NAME	DATE	TITLE
HARDEN	1/19/64	WIRING DIAGRAM - AUXILIARY FUEL PUMP - LEFT MAIN
CHECK	8/15/64	
APP'D	8/15/64	
SUPERVISOR	8/15/64

MODEL	REV	PAGE
337	B	7.1

WIRING DIAGRAM - AUXILIARY FUEL PUMP - LEFT MAIN

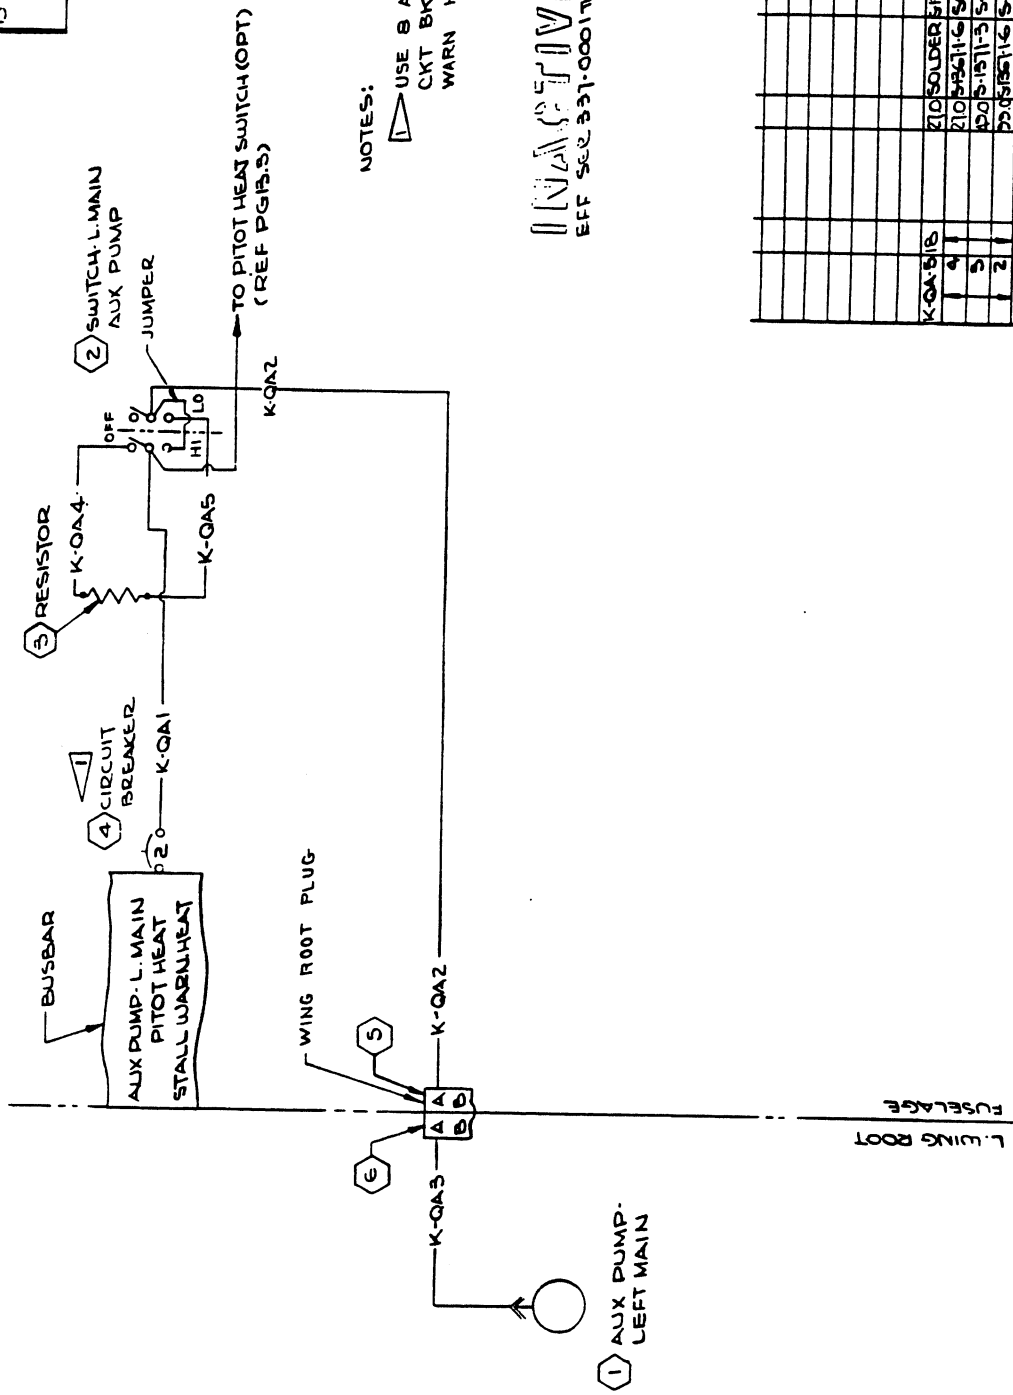
CHG LET	REVISION	BY	DATE
A	IN EQUIPMENT TABLE: AR 25-15 RESISTOR WAS AR 25-20	UNNA	12/16/66
B	ALL WIRES RECHANGE WIRE WAS 20 GAUGE TO 18 GAUGE. 210S1511-3 WAS 210S1511-2. 210S1511-3 WAS 210S1511-2. 210S1511-3 WAS 210S1511-2. 210S1511-3 WAS 210S1511-2. (528073)	UNNA	12/16/66

DETAIL A
THRU SER 337-0787

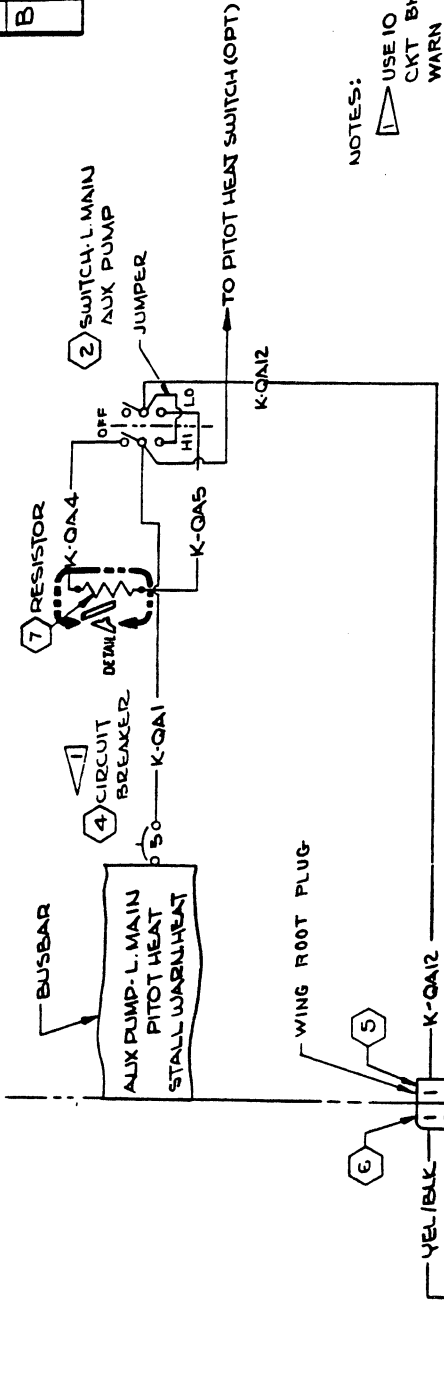
CHG	BY	CHK	REVISION
A	WMA	WMA	1. FIELD REPAIR TABLE. 1. 10 AMP WARM STALL HEAT WAS 2. SER 337-0526 WAS 2. SER 337-0526
B	RCA	RCA	BY REV: ADD DETAIL "A" & AR-25-20 ED & RR 00110
